Camping provision in the National Park and the Loch Achray campsite

The main flaws in the proposed Loch Achray campsite

CAMPING PITCH DESIGN

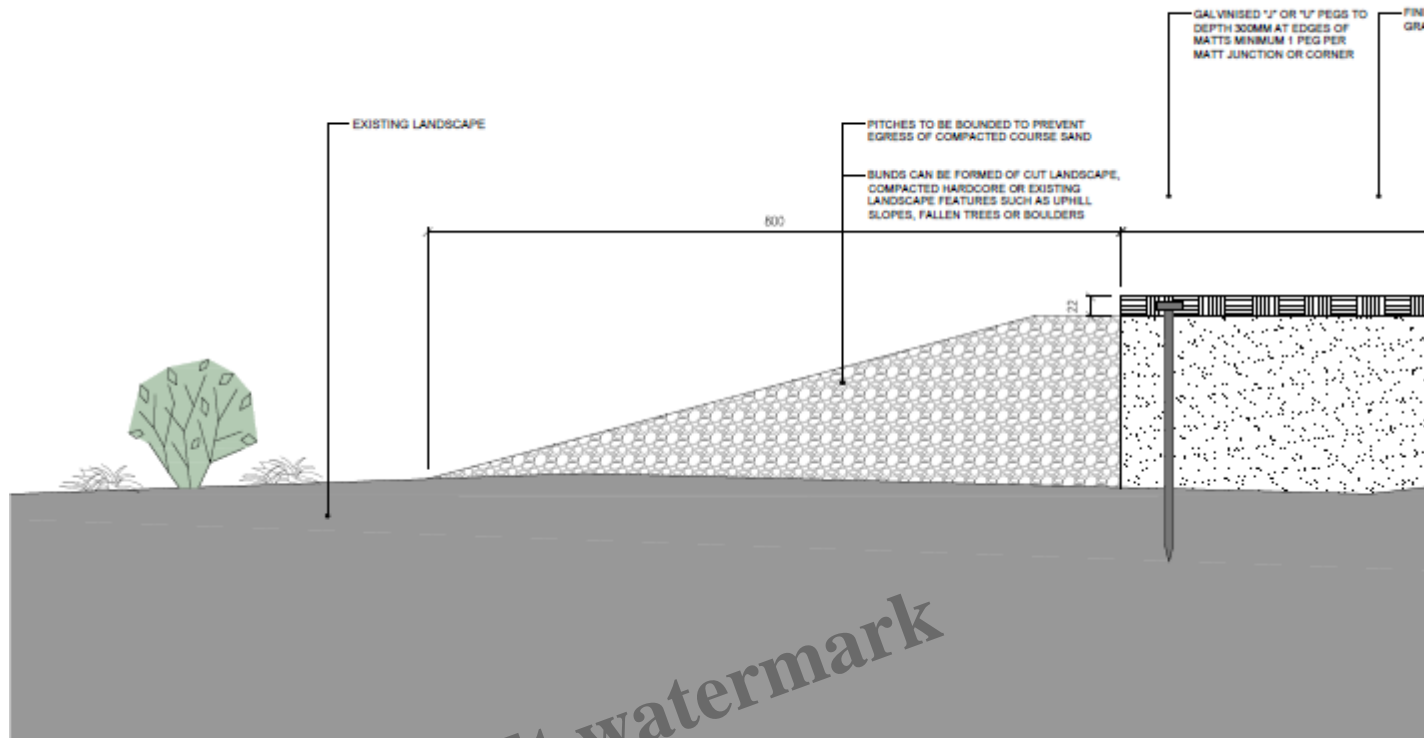
Camping on bark is horrible and describing it as traditional is simply "parkspeak". However, it appears that the current proposal is for rubber pitches on raised sand beds:

No-one from the Park appears to have asked any campers whether they like camping on artificial mats – although I guess if people were asked they might suggest their use on some of the sloping pebble beaches which the Park has designated as camping permit areas!

While some work might be required to create the 3 camping pitches on the west side of the burn, where the land is boggy and overgrown, this could be done without rubber matting. NO artificial pitches are needed in the largest camping area on the east side of burn.

2.3 Off Site Management / Resources

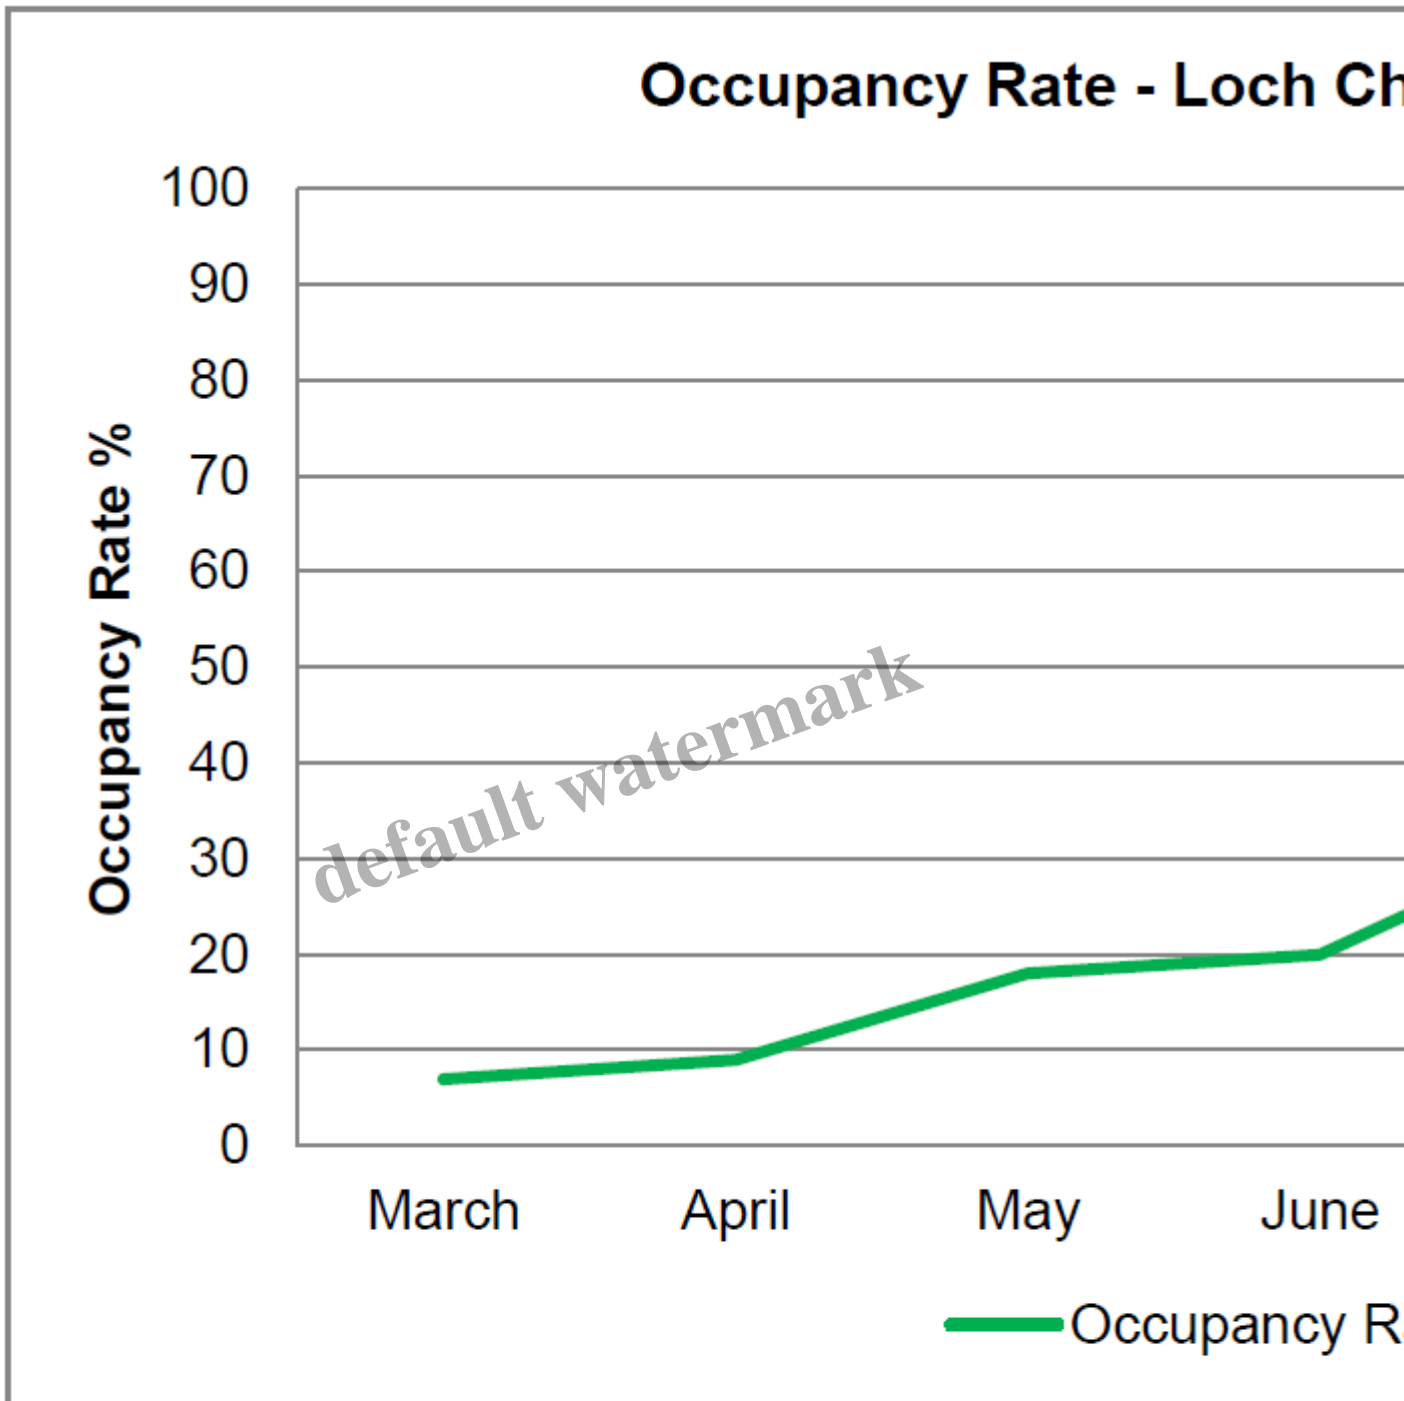
This is madness which appears driven by the need to get SEPA to withdraw their objection. The Loch Achray site is actually much better and safer for camping than some of the camping permit areas created by the Park which are regularly underwater and unusable (e.g the beaches at Firkin Point). The difference though is the permit areas never required planning permission. More hypocrisy from the LITNPA and other agencies. Should SEPA not have been objecting to many of the permit areas because of their flood risk?

The cost implications of this staffing are significant. 10 hours at even £10 per hour (minimum wage plus on costs) is £100 a day. 17 places are planning and lets the campsite does twice as well as Loch Chon, which was always too big and is more remote and whose occupancy is as follows:
